**Design, Manufacture, Fabrication, Supply, Erection, Testing, Commissioning and handing over of firefighting facilities at 3rd Oil Jetty, HDC**

**E-tender: 2020\_KoPT\_552085\_1**

**♠ADDENDUM-III♠**

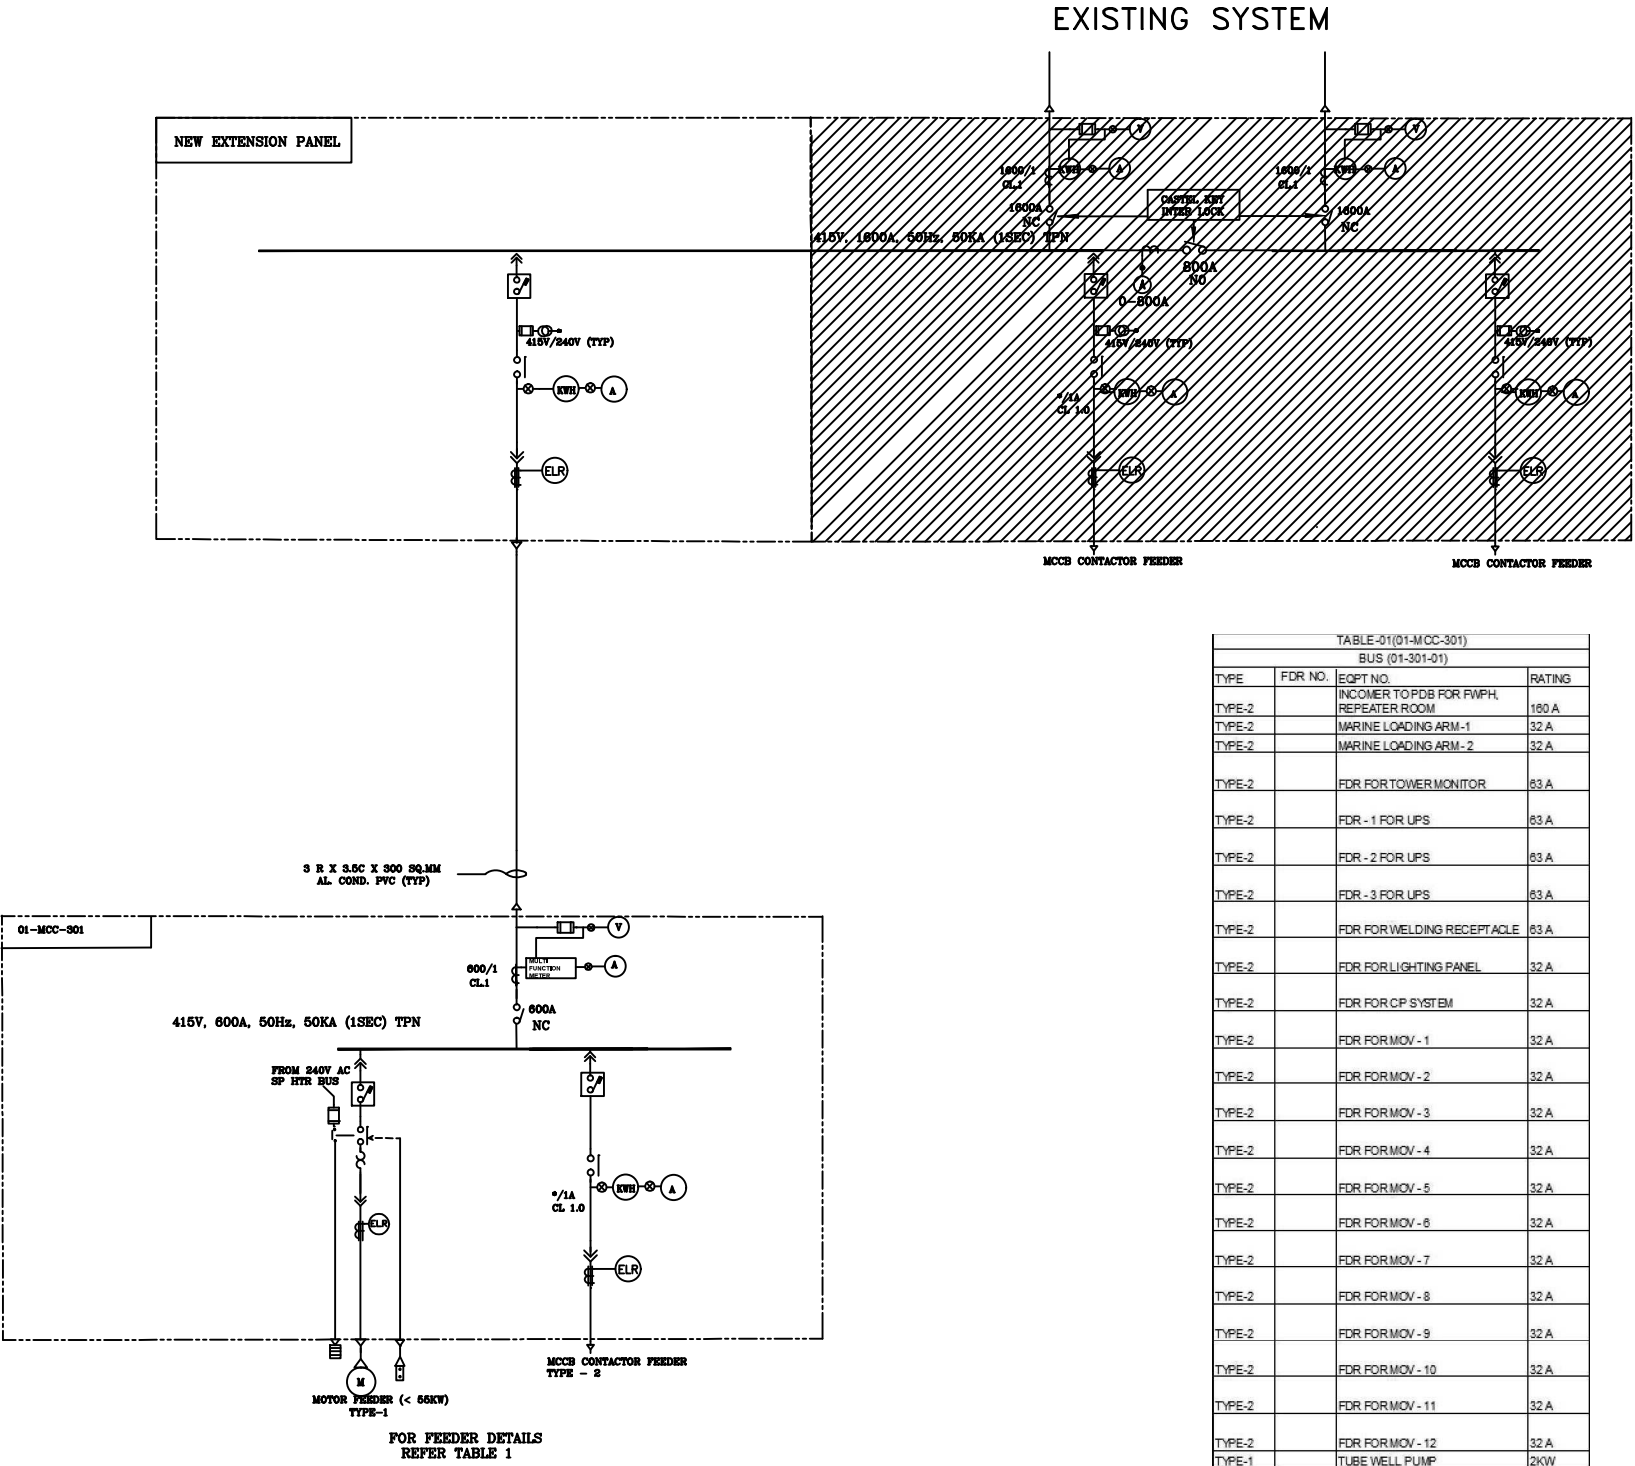
35.	General		Kindly provide the SLD/schematic for Electrical scope.	Pl. refer to <b>Annexure-IV of Addendum-III for SLD.</b>
36.	Scope of Supply Sl.No.6.78 & Page 99	All statutory approvals required for design, supply, and installation and commissioning of individual equipment and for system as a whole are included in contractors' scope of work.	We shall assist you with necessary documentation , drawing and required demonstration of Performance test to statutory approval team. Necessary fees shall be paid by HDC directly to authority. Please confirm	The proposed work consisting of augmentation of existing jetty with fire fighting Equipment as per OISD-156. However, the final as build drawing shall be made by the contractor after installing all the equipments at site along with few item installed by BPCL and the same drawing is forwarded to PESO with the approval of HDC. The necessary arrangement to be made by the contractor for approval of the drawing with the support of HDC.

1. Single Line Diagram indicates proposed scheme of supply, & distribution of power for complete Jetty electrical works.
2. Equipment rating, wherever is indicated, shall be considered as minimum rating. Rating as required or as available shall be supplied. The Single Line Diagram shall accordingly be revised by Contractor.
3. MCCB's shall be 4 pole and non-drawout (fixed type).
4. Relay, Metering, lamps shown are indicative and minimum, Any Auxiliary Relay, Metering, lamps, control swith, required CT/PT Burden etc as deemed necessary for feeder function shall be provided.
4. Multifunction meter shall be communicable type. All data current, voltage & KWH shall be communicable to SCADA/PLC panel (supplied by others). Hookup of multi function meter to SCADA panel including supply & laying of cable is in bidder's scope.
